Access Compliance Report

Public Rights-of-Way

Intersection ID: 32292	Main Street: OLD_ARDREY_KELL_RD	Cross Street: HONEYNUT_DR	Location: SW
ADA ID: 418207A5B221	Ramp Type: Combination1Diag	Initial Pass/Fail: Fail	Overall Compliance: No
Severity Score: 0			
Codes/Mitigation Info/Possible Solution		Field Measurements/Component Compliance

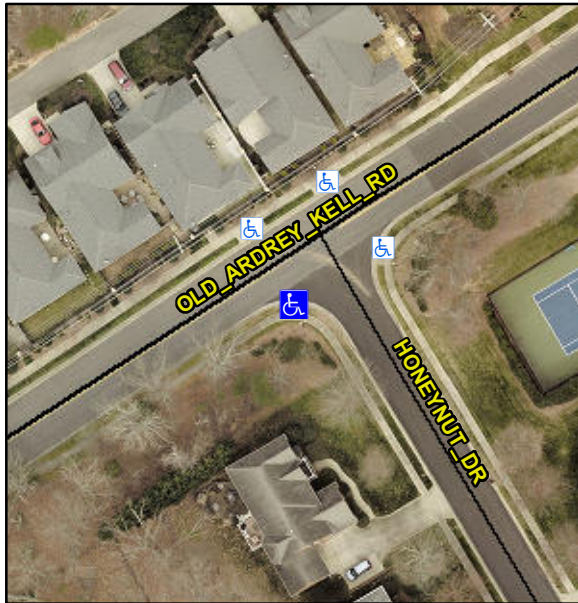
CURB LIP 0.5

R304.5.3

Remove & Replace Curb Ramp With Two New Directional Ramps or Equivalent.
